WATER QUALITY MEMORANDUM

Utah Coal Regulatory Program

RE: 2nd Quarter 2019 Water Monitoring, Wolverine Fuels, Fossil Rock Mine, C/015/0009, Task ID #5959

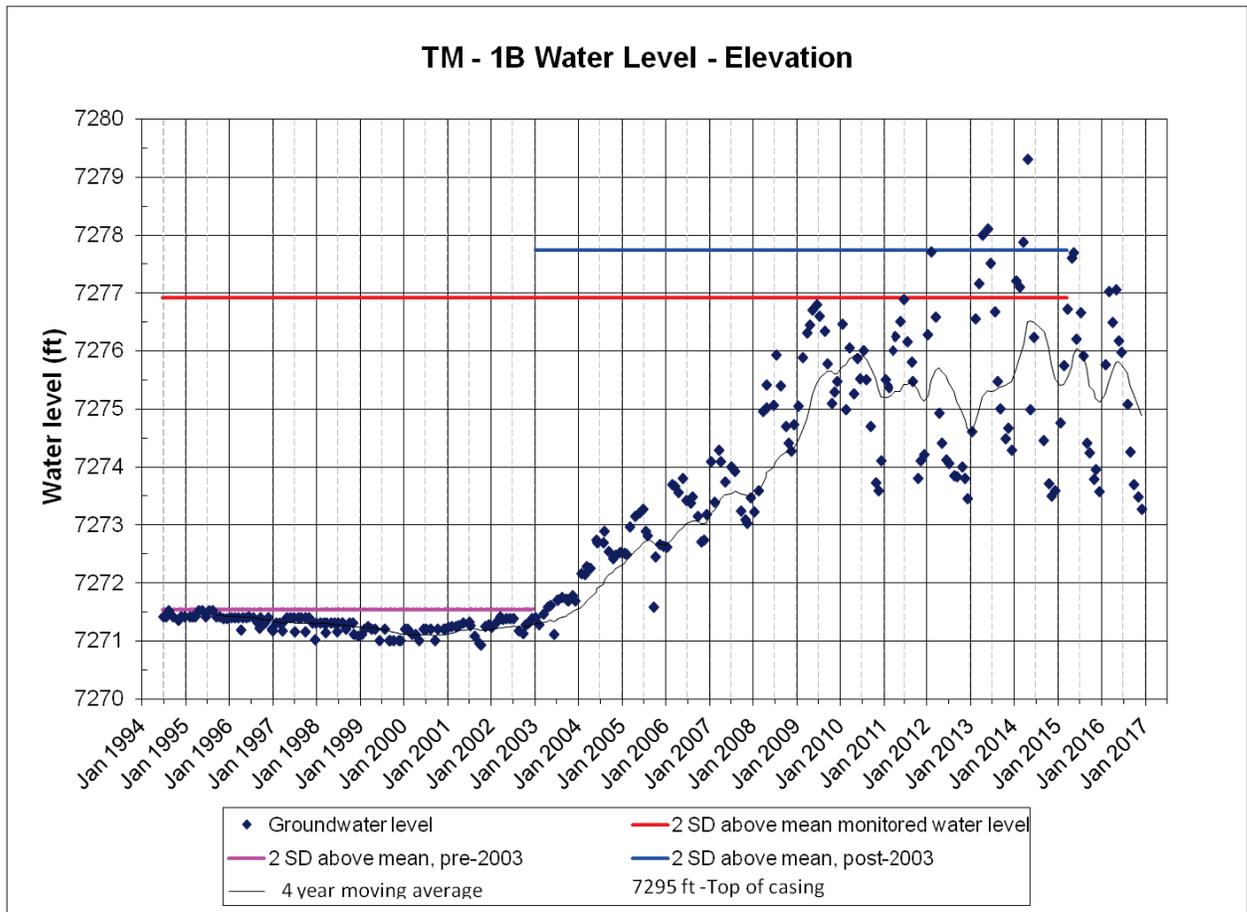
Figure 1. The water level in TM-1B has been rising since mine dewatering ceased in May 2001. It's difficult to say where the water level will come to rest. The well is completed in the Panther tongue of the Star Point sandstone below the mine workings. This sandstone tongue contacts the floor of the mine workings. Mine dewatering reduced the potentiometric head within the unit and the mine pool is probably recharging the unit. *This graph will be updated when mining begins in the Cottonwood tract.*

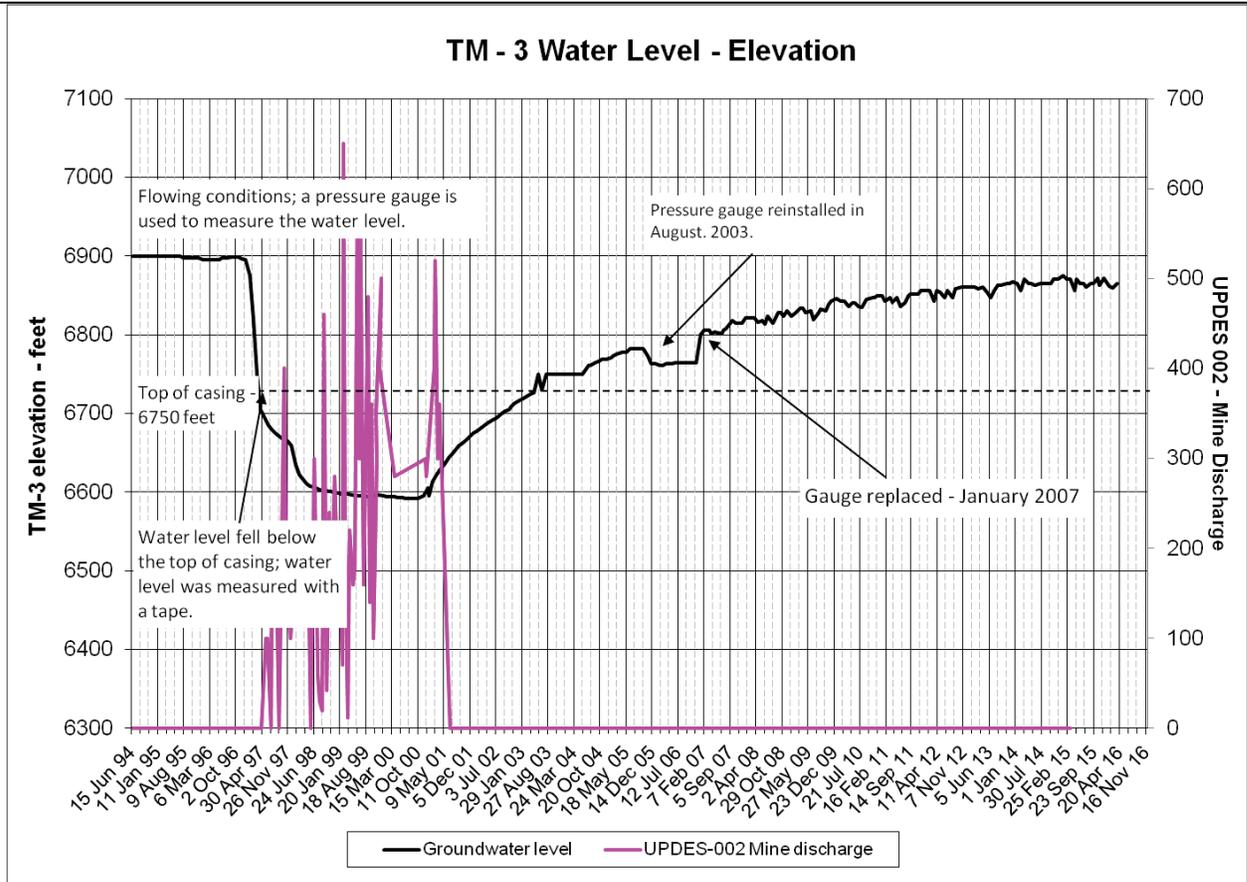
Figure 2. TM-3 water elevation peaked in June 2005, remained steady through October, dropped 18.5 ft in November and December 2005 and remained virtually unchanged during 2006. The pressure gauge was replaced in January 2007 and values jumped to approximately match the pre-2006 curve. During the first half of 2007 the curve was relatively flat, but it has been steadily climbing. The outgoing document Reduce Hydrologic Monitoring Sites, PacifiCorp, Deer Creek, C/015/0018, Task ID #4332 stipulates this well should not be released until 6,900 ft is reached. *This graph will be updated when mining begins in the Cottonwood tract.*

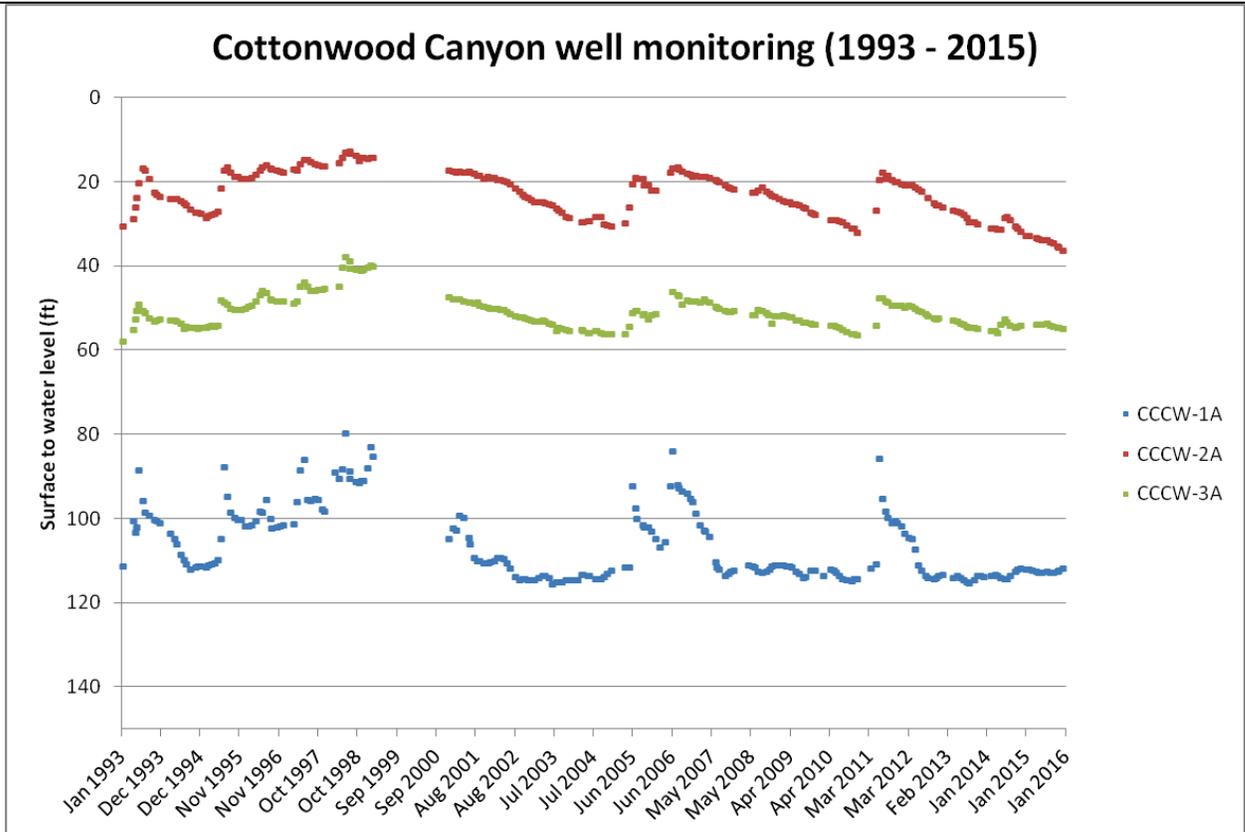
– 2A, CCCW – 3A, CCCW – 3U, CCCW – 3L are monitored for water level only (Figure 3 shows alluvial wells).

Figure 3. Alluvial aquifer water levels in the Cottonwood Canyon Creek monitoring wells. The drill hole data is found in Trail Mountain MRP Appendix C p. 23. This graph will be updated when mining begins in the Cottonwood Track. The wells primarily respond to climatic variability. *This graph will be updated when mining begins in the Cottonwood tract.*
